February 20, 2024  
Updated April 17, 2024

Re: **Civil Engineering Peer Review Response**  
Farm Road Homes – Comprehensive Permit

Creative Land & Water Engineering, LLC (CLawe) has received and reviewed the Civil Engineering Peer Review Letter from Tetra Tech (the “Reviewer”) updated October 27, 2023 updated March 15, 2024. This letter provides our responses. To facilitate the review, we will quote the prior Reviewer’s comments and our answers first and provide our answer to the latest comments in red.

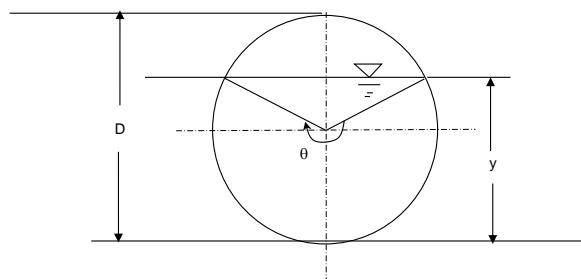
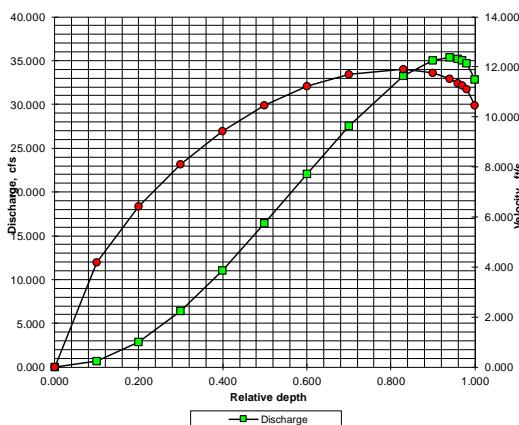
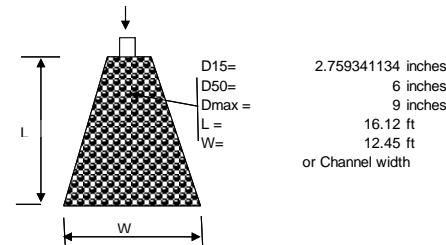
- TT 3/15/24 Update: We agree with the Applicant's representation related to off-site tributary area to the site from the north. However, the Applicant noted that the cross-culvert at the driveway for the existing homes at 53 and 55 Farm Road is one of the control points for the analysis (CP #2). **As such, any flow tributary to that culvert should also be included in the analysis to ensure it is sized accordingly to pass tributary flow. An existing conditions watershed plan should also be included in the analysis for reference.**

- **CLAWE 4/17/2024: The flow to the culvert under the driveway of 53 Farm Road is total flow and it is far less than the 24" culvert capacity. The culvert capacity analysis sheet is provided below for easy reference.**

For the given condition:  
Discharge Q (cfs) = 8.31  
Width/Dia. B (in) = 24  
Roughness n = 0.023  
Slope slope = 0.0661  
Design Vel V (ft/s) = 6.65  
Flow Depth (ft) = 0.58  
Channel riprap size:

Stone specific gravity (Ss): 2.65  
Stability factor (Sf): 1.2  
Stone repose angle (Φ): 42.00  
Bank slope angle (θ): 18.00  
D50 correction factor (C): 1.00  
Bank angle correction K1: 0.887  
D50 (in) = 5.52

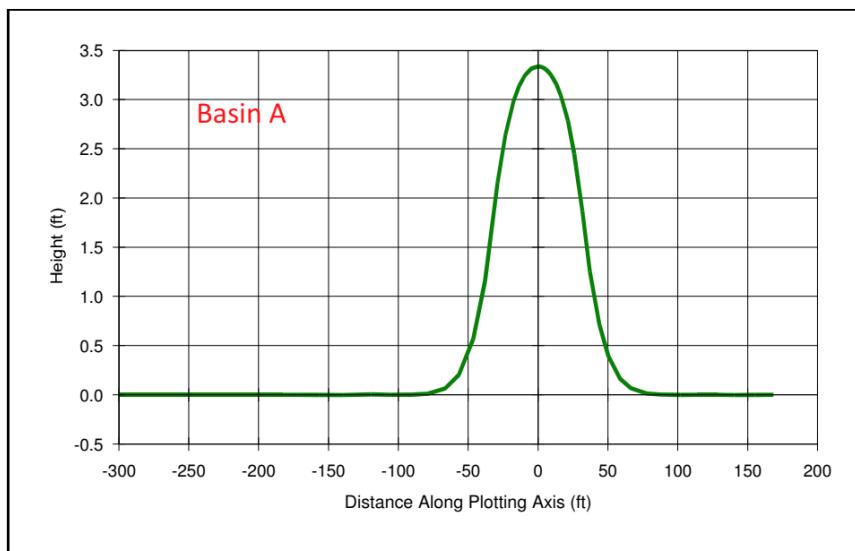
d) Once the groundwater mound has been recalculated per the DEP Model, the mound would need to be fit into the groundwater flow map to determine groundwater divides for calculation of the AOI for the nitrogen loading model, in accordance with the DEP model parameters.

**Response:** The groundwater map is updated with the groundwater mounding height incorporated into the groundwater elevations in the SAS area. Stormwater basin has only short term mounding and is located upgradient of SAS area more than 100 ft. It will not impact the overall groundwater flow pattern. See Appendix D for updated groundwater flow map.
